REMARKS

Serial No. 09/820,512
Amendment to Office Action of 8/16/2004
Annotated Sheet Showing Changes

FIG. 6A

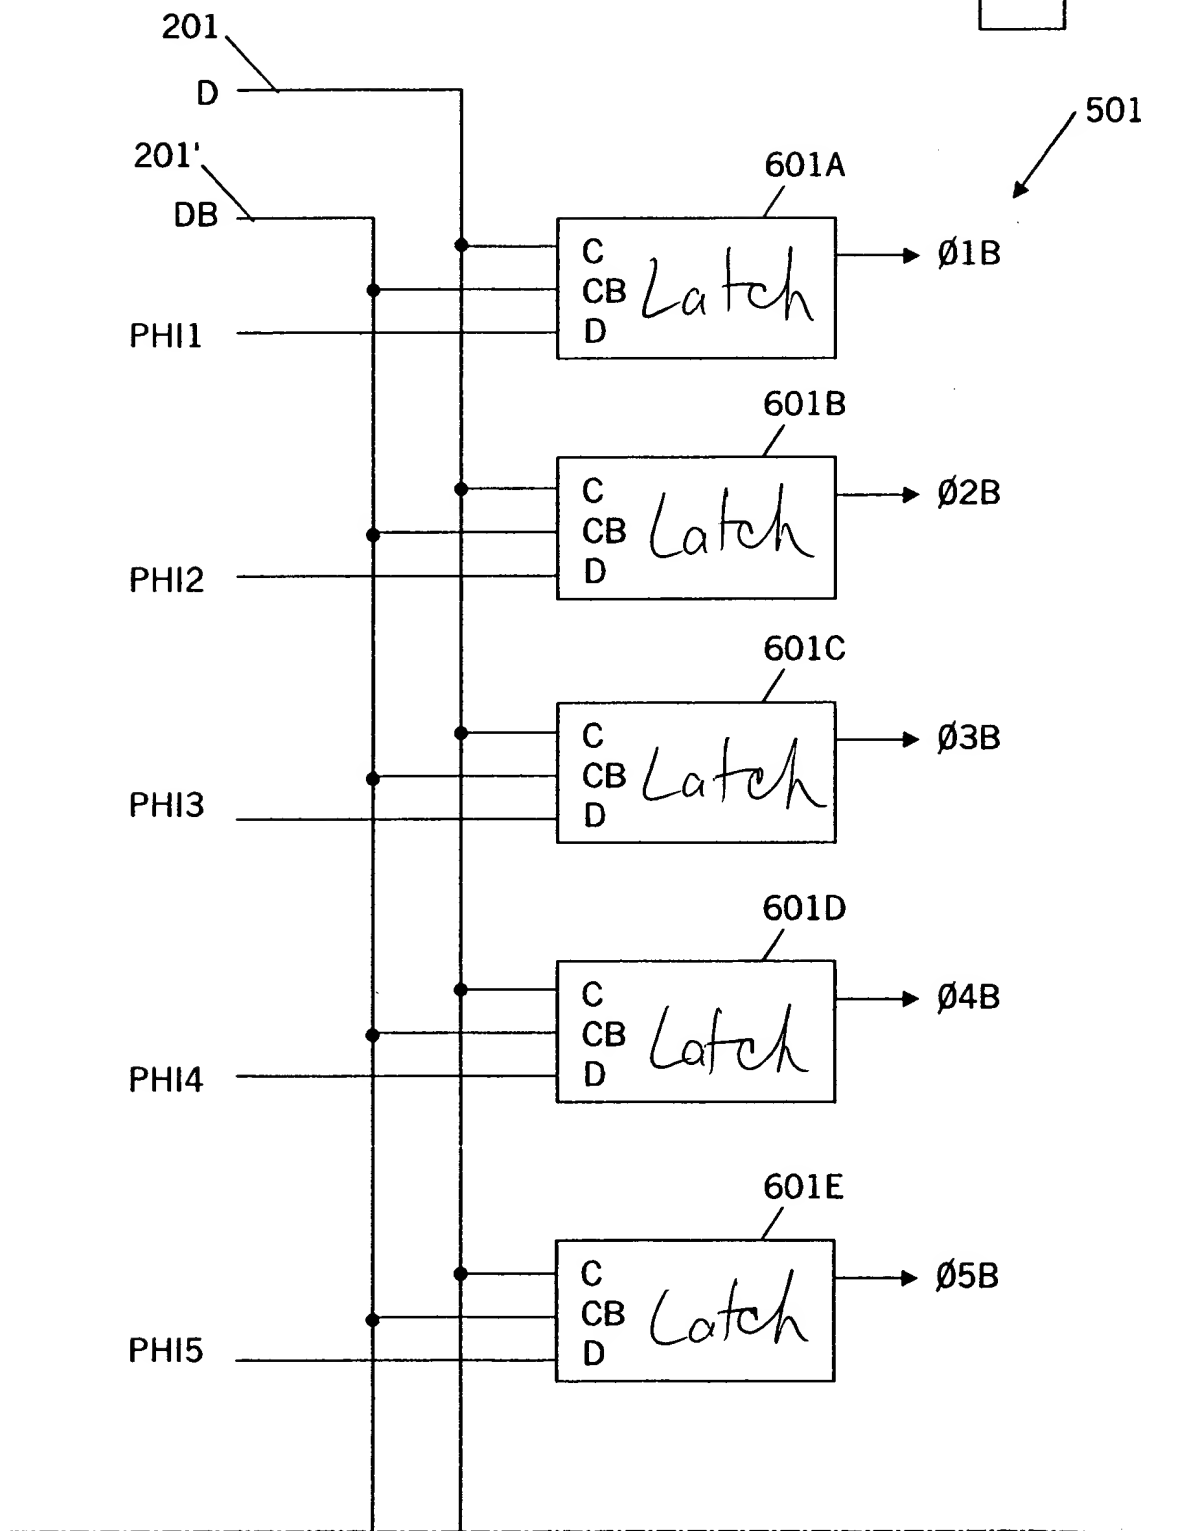
The Examiner has objected to Figure 3 because the reference sign "T9" should be "T7". The Examiner has further objected to Figure 7 because the reference sign "Out" should be "OutB." The Examiner has further objected to Figures 6A-B for missing a label for elements 601A-J. In response, Applicant has amended Figure 3 to include the appropriate reference sign "T7," Figure 7 to include the appropriate reference sign "OutB," and Figures 6A-B by adding the label of "Latch" to elements 601A-J.

Please amend Figures 3, 6A-B and 7 as shown on the attached annotated sheets. Replacement formal drawings are also attached.
